## NVM Express™ Technical Errata

<b>Errata ID</b>	<b>003</b>
<b>Revision Date</b>	<b>6/3/2015</b>
<b>Affected Spec Ver.</b>	<b>NVM Express™ 1.2</b>
<b>Corrected Spec Ver.</b>

### Errata Overview

**Figure TBD X: Protection Information Processing for Compare**

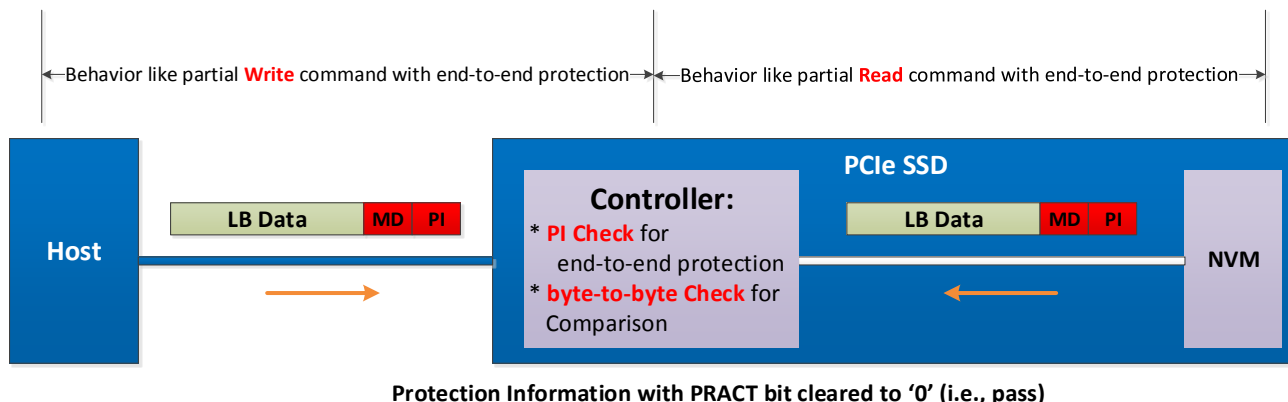
Figure TBD X illustrates the protection information processing that may occur as a side effect of Compare command processing. Compare command processing ~~is the same as that for a Read command except that no data is transferred to the host.~~ parallels both Write and Read commands. The controller checks the protection information contained in the command and the protection information read from the NVM.
